Access Compliance Report

Public Rights-of-Way

(Curb Ramps)

Intersection ID: 10028419	Main Street: HIGHGROVE_ST	Cross Street: N/A	Location: NW
ADA ID: 82C7E1BA29EA	Ramp Type: PerpDiag	Initial Pass/Fail: Fail	Overall Compliance: No
		Severity Score: 22.5

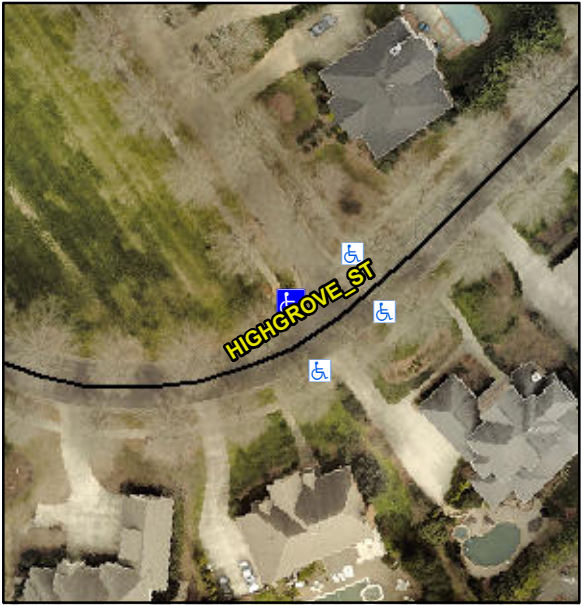
Codes/Mitigation Info/Possible Solution			Field Measurements/Component Compliance		
	Possible Solutions:		Compliance	Description	Data
	Remove & Replace Curb Ramp With Two New Directional Ramps or Equivalent.		No	Ramp Length (in)	96.0
			No	Ramp Width (in)	46.5
			N/A	Flare Type LT	N/A
			N/A	Flare Slope LT (%)	N/A
			N/A	Flare Traversable LT?	N/A
			N/A	Landing Length (in)	N/A
			N/A	Landing Width (in)	N/A
			N/A	Landing Slope (%)	N/A
			N/A	Landing X Slope (%)	N/A
			N/A	Landing Curb? (Y/N)	N/A
			N/A	Shared Landing?	N/A
			N/A	Gutter Ponding?	N/A
			N/A	Gutter Lip Ht (in)	N/A
			No	Painted X Walk1?	No
				X Walk 1 Direction	To S
			N/A	X Walk 1 Width (in)	N/A
				X Walk 1 Slope (%)	5.2
				X Walk 1 X Slope (%)	0.7
			N/A	Ramp inside XWalk1?	N/A
<p>Surveyor Notes:</p> <p>N/A</p> <p>PROW/ADA:</p> <p>R304.5.1, R304.2.2, R304.5.3</p>			N/A	Flare Type RT	N/A
			N/A	Flare Slope RT (%)	N/A
			N/A	Flare Traversable RT?	N/A
